Addendum No.: 1

Bid#: 26-41-2

Project Name: French Branch Pond Expansion

Addendum No. 1
French Branch Pond Expansion
Parish Project No. EN23000124

SHEET

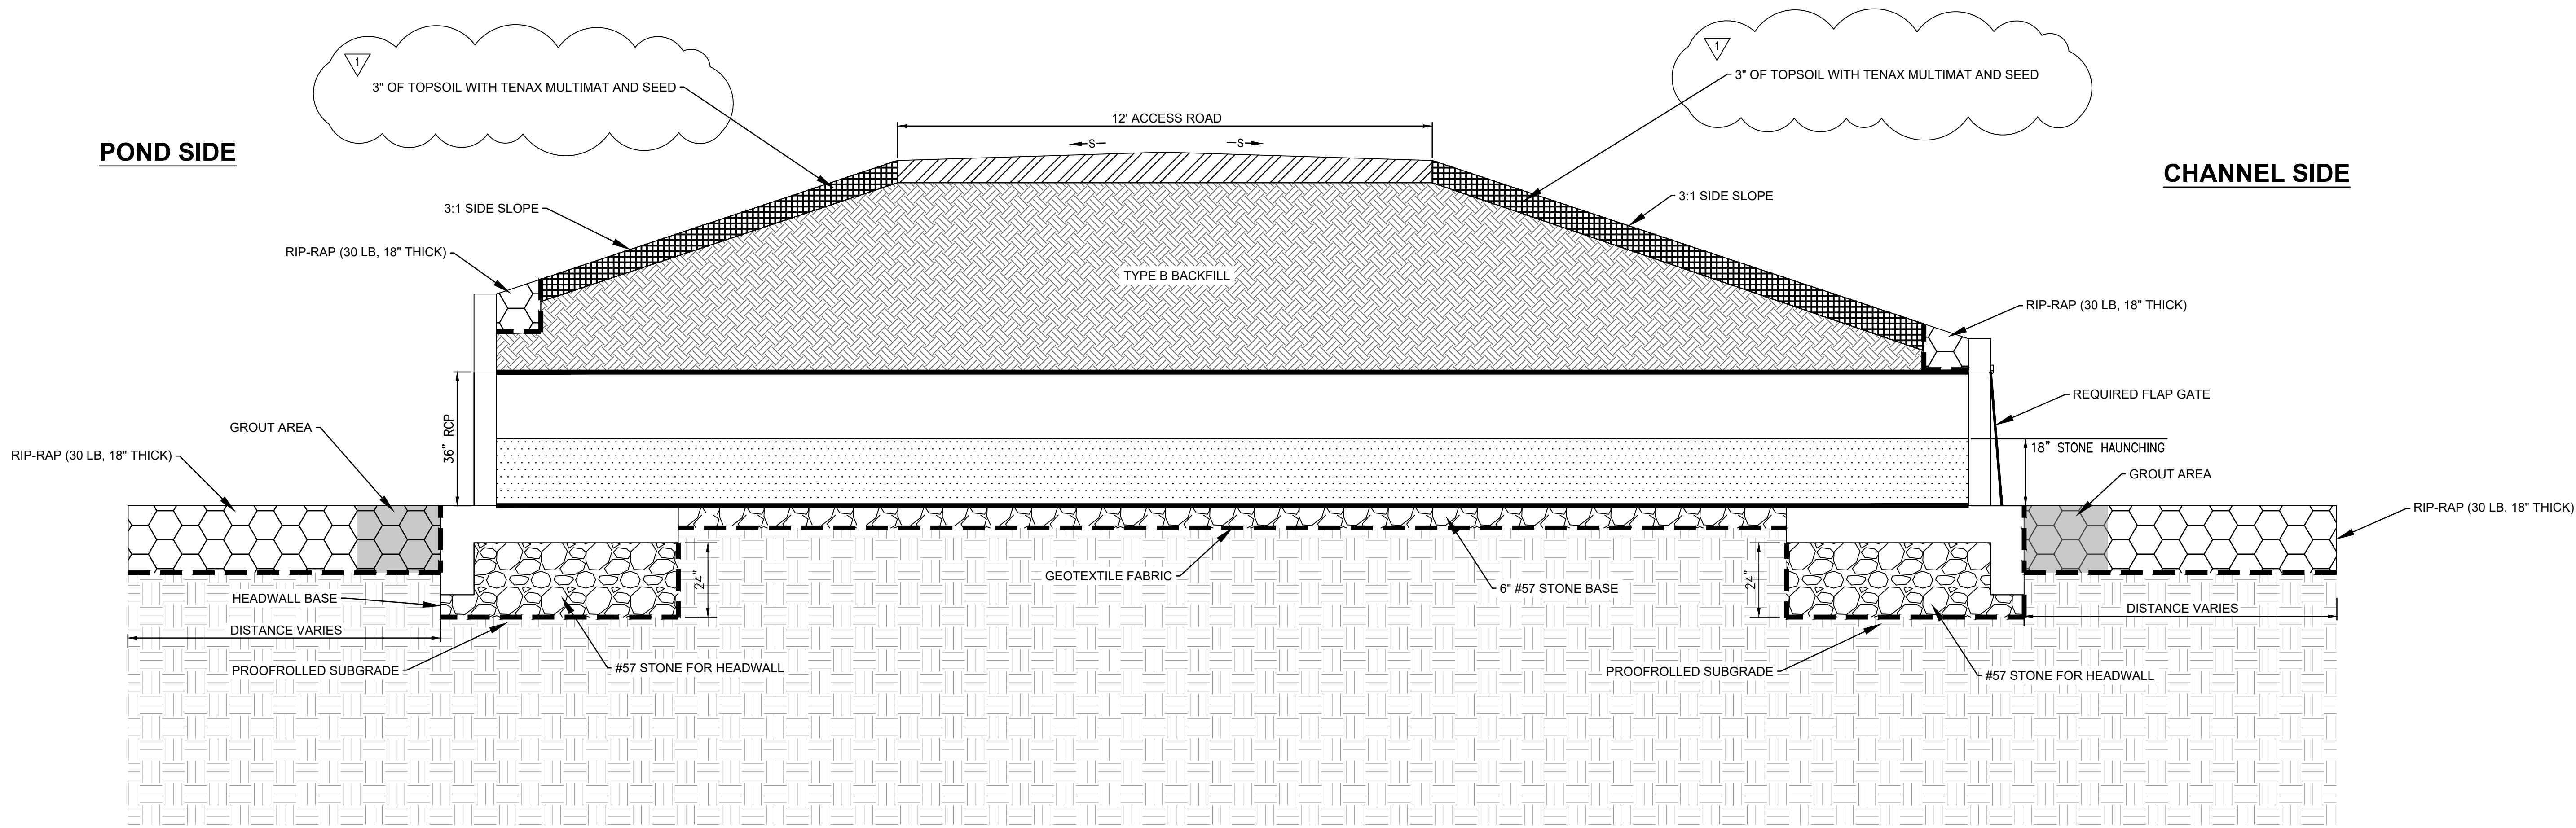
4. Plan Sheet C-4.3 has been revised to remove reference of Plastic Soil Blanket.

DATE 9/23/2026 REVISION 1 BY CMR/KPB
9/23/2026 - SOIL REQUIREMENTS - CMR
